AGENDA OF THE PLANNING
COMMISSION
CITY OF BIRCHWOOD VILLAGE
WASHINGTON COUNTY, MINNESOTA
May 23rd, 2024
7:00 P.M.

STAFF REPORT

Scope: OHWL Setback Variance
Applicant: Schifsky Companies, LLC

Representative: Carson Schifsky
Property Location: 425 Lake Avenue

CERTIFICATE OF SURVEY

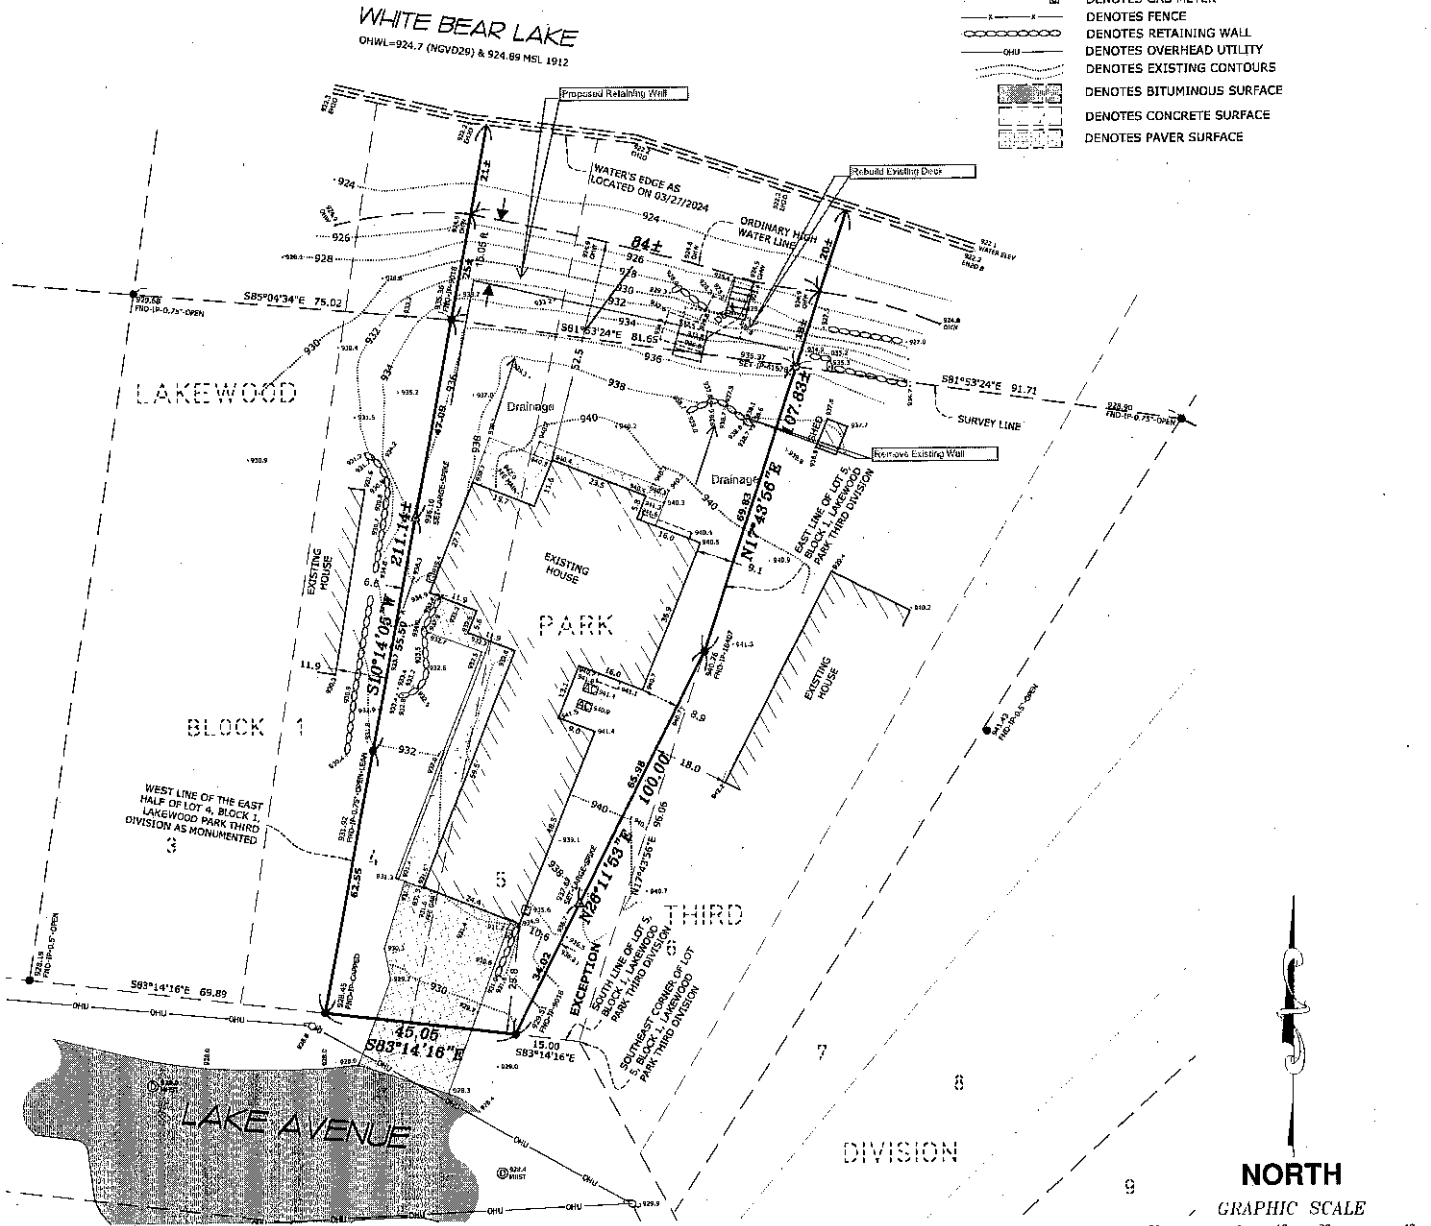
One item of note is the impervious surface. The survey shows a total impervious percentage on site of 40.2%, while the chart on the application shows 31.69%. It appears that the existing pavers and concrete elsewhere on site were left off the chart. The 33 s.f. of additional retaining wall is assumed to be correct for one tier of wall. That is staff's understanding of the proposed wall design based on correspondence from the applicant, and seems to make sense with a 50-foot wide lot. If that is the case, the proposed impervious percentage on the chart is calculated incorrectly (it adds 103 s.f. to the existing total, rather than just the new 33 s.f.). The applicant should be present to clarify. Regardless, the amount of impervious to be added is negligible, and necessary for the mitigation. 33 s.f. of additional surface would be 0.2%; 103 s.f. of additional surface would be 0.81%.

1. Add erosion control and stabilization methods to the plan set with a key.
 - Erosion control measures should be located down gradient of all land disturbing activities. **As land disturbance is proposed within 50 feet of a waterbody redundant erosion control BMPs are recommended in these locations.**

- **For disturbed areas what is the proposed stabilization method seeding, sodding, etc.?**
2. Update work areas/land disturbance areas to include stairs and deck.

3. Based on the below RCWD definitions, state the total area of proposed new and/or reconstructed impervious surface. If none, please state – if removing impervious surface please state the square footage:

4. State the RCWD regulatory floodplain elevation of White Bear Lake 927.2 NAVD 88
5. The project will need to calculate any cut (removal) and fill within the floodplain. Compensatory floodplain storage volume is not required for a one-time deposition of up to 100 cubic yards of fill, per parcel, if there is no adverse impact to the 100-Year Flood Elevation. If 100 cubic yards or greater is proposed, mitigation is required for the entirety of fill. Calculations showing worked out methodology will need to be provided between OHW and RCWD 100-year floodplain. For example, this calculation could be $(LxWxD)/27 = \text{cubic yards}$. Ensure to include rock, sand, dirt, concrete, etc.
